Installation of open sprinklers along outside wall towards Fox Street  
of building at 34 Diamond Street.

CITY OF PORTLAND, MAINE  
DEPARTMENT OF BUILDING INSPECTION

Issuance of the certificate of occupancy for your new factory at 148-166 Smith Street is and has been delayed because of the report of our inspector as to the loading of a certain part of the roof framing. The purpose of this letter is not only to draw your attention to this question, but to serve as a warning that no more weight of any kind should be added to any part of the roof structure (either hung from below or superimposed above) without securing a new permit therefor from this department and with the application for such a permit filing plans and detailed investigation and design by a competent party to show that the roof will not be overloaded.

Plan by  
Leo Wilson

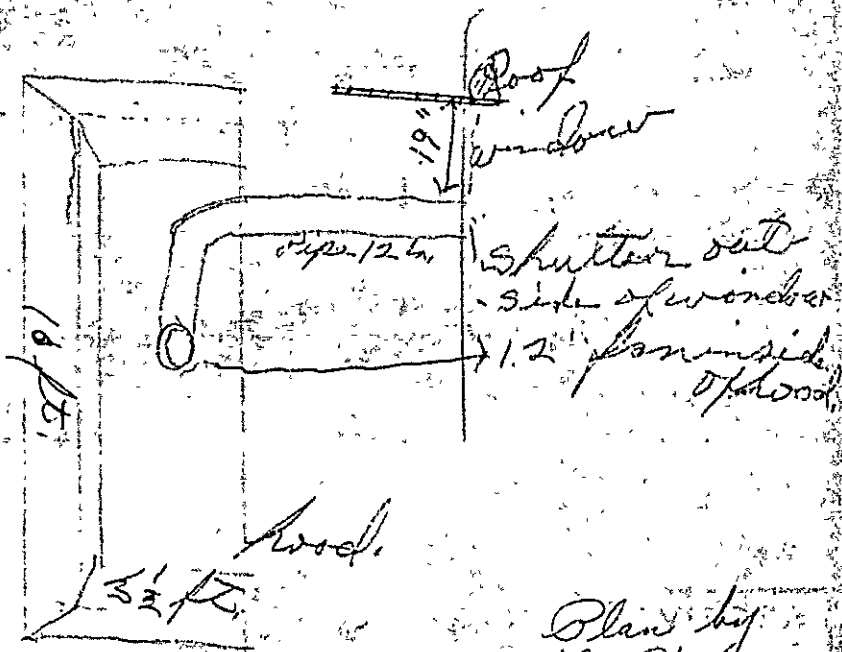
His sketch of the hood and ventilating duct and fan does not show the distance from the hood to the nearest wall. If this wall contains no combustible material or there is to be no burnable material within 12" of the edge of the hood, this dimension is then unimportant. If there is to be any wood or other burnable material within 12" of any edge of the hood, then the work of installation should not be started but the permit returned with full information as to the location of the wood or other burnable material and what is to be done to protect it.

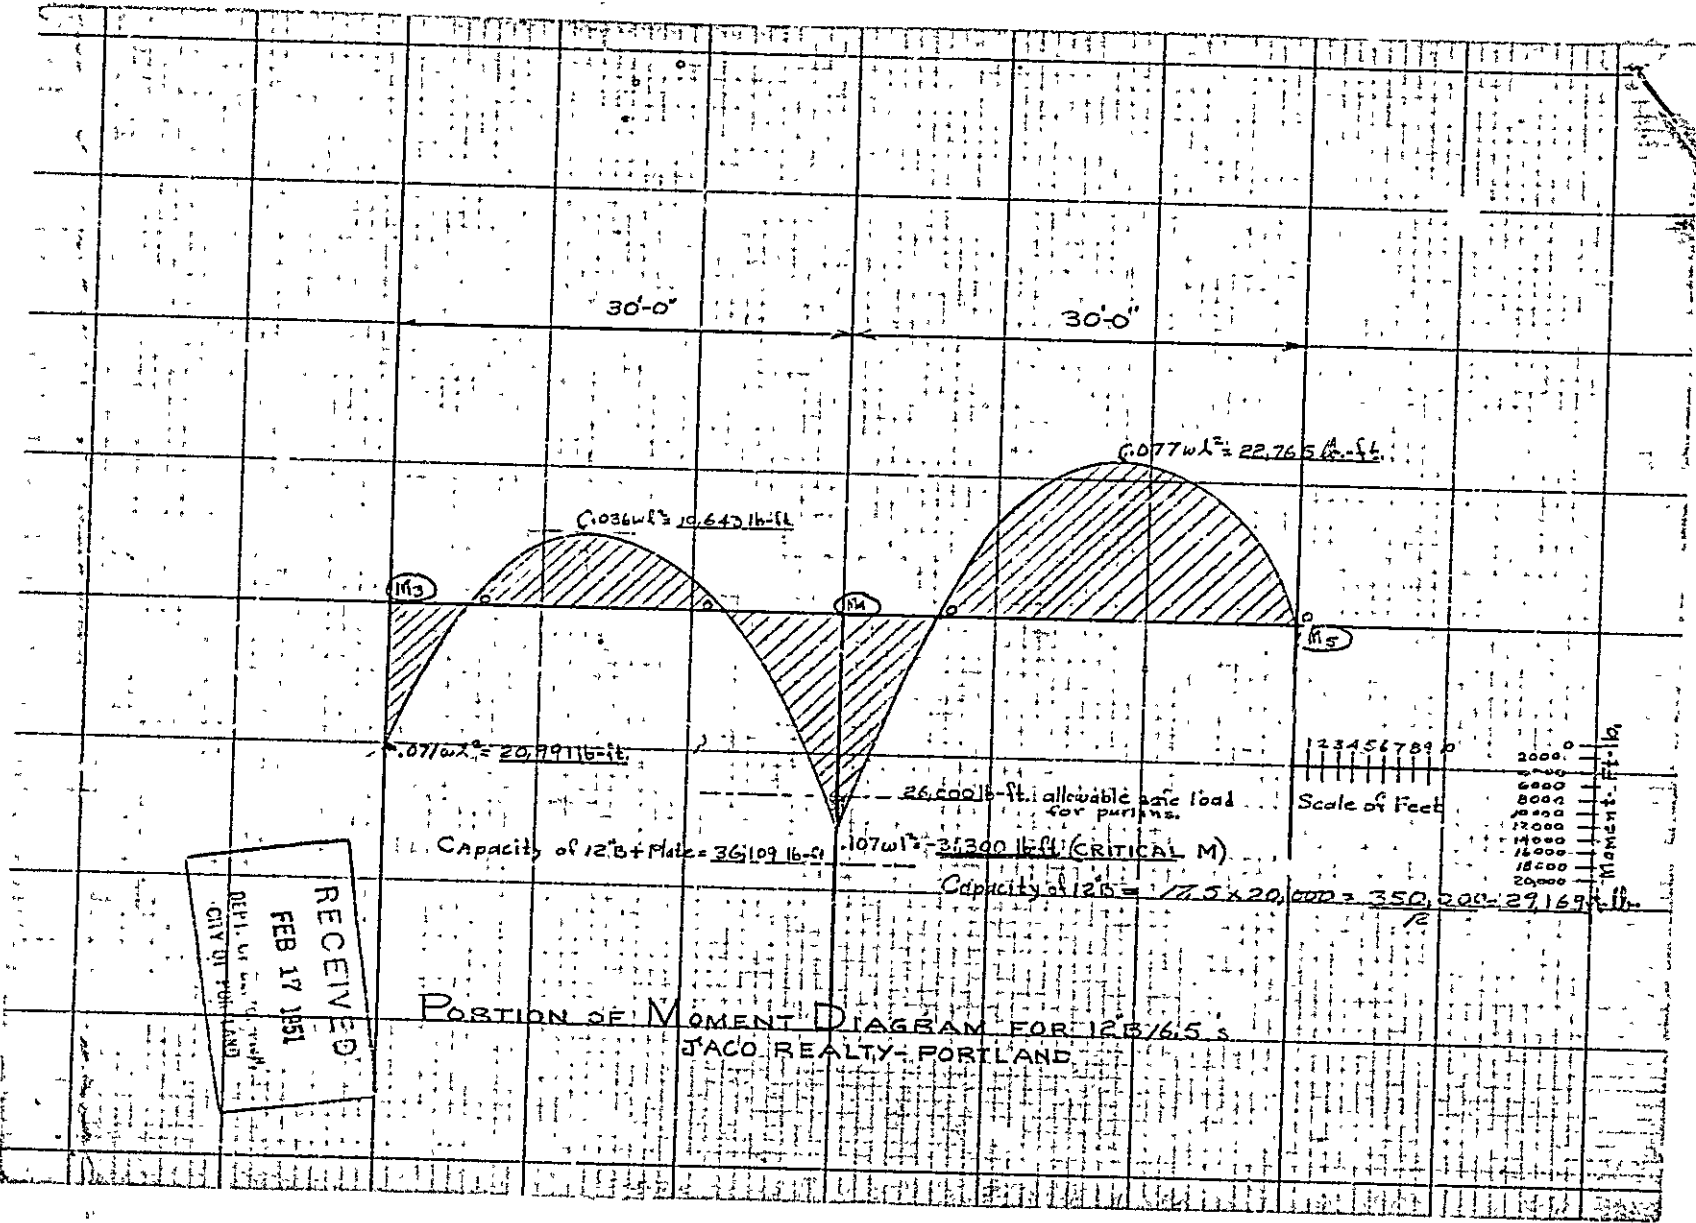
Reinforce each 12" B. purlin subject to super-imposed concentrated load by welding 10" x  $\frac{1}{4}$ " x 3'-0" plate to web over first interior support, (point ④)
